APPLICATION NO.	FILING DATE	FIRST NAMED INVENTOR	ATTORNEY DOCKET NO.	CONFIRMATION NO.
10/576,016	04/17/2006	Jean-Philippe Oi	0513-1172	8822
466 7590 12/24/2009 YOUNG & THOMPSON 209 Madison Street Suite 500 Alexandria, VA 22314			EXAMINER EPPS, TODD MICHAEL	
			ART UNIT 3632	PAPER NUMBER
			NOTIFICATION DATE 12/24/2009	DELIVERY MODE ELECTRONIC

Office Action Summary

This is the second Office Action **final** for serial number 10/576,016, Method For Position Indexing Of A Machine Or Similar On The Floor And Machine Leg Used Therefor, filed April 17, 2006.

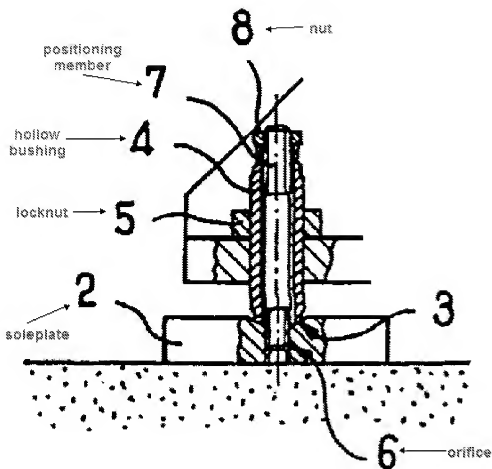
Claims 10, 12, and 17-22 are rejected under 35 U.S.C. 102(b) as being anticipated by Applicant Admitted Prior Art (AAPA) as identified by Figure 1 of the drawings (as shown in the marked-up below), and pages 1-2 of the specification, which the applicant submitted.

The prior art discloses a machine leg for indexing a machine in position on the ground, comprising: a hollow bushing; a soleplate forming a bottom of the bushing and having an orifice through the bottom of opening out into the bushing; a positioning member, which can be from a drilled hole in the ground; wherein the orifice is sized to

cooperate with the positioning member; the positioning member is configured to pass through the bushing along a length of the bushing and through the orifice into the drilled hole in the ground, the drilled hole in line with the orifice, thereby positioning the machine on the ground for indexing; further comprising: a nut for anchoring the bushing and wherein the positioning member is securable to the ground; and the positioning member has a threaded free end (top portion) and the nut bearing against an inside face of the bottom of the bushing; wherein a diameter of the positioning member (outer diameter) matches a diameter of the orifice (inner diameter); wherein the soleplate is fixedly secured to the hollow bushing (connected by the recess - 3); a lock nut configured to engage with an outer surface of the hollow bushing to secure the hollow bushing in position

Claim 11 is rejected under 35 U.S.C. 103(a) as being unpatentable over Applicant Admitted Prior Art (AAPA) as shown above in Figure 1.

The prior art fails to disclose wherein the soleplate is integral with the hollow bushing. Nevertheless, it would have been obvious to one ordinary skill in the art at the time the invention was made to have modified the soleplate and the hollow bushing of the AAPA to include a single integral continuous piece because one would have motivated to provide a one piece construction for manufacturing purpose and it would be merely a matter of obvious engineering choice. *In re Larson*, 340 F.2d 965, 968, 144 USPQ 347, 349 (CCPA 1965).
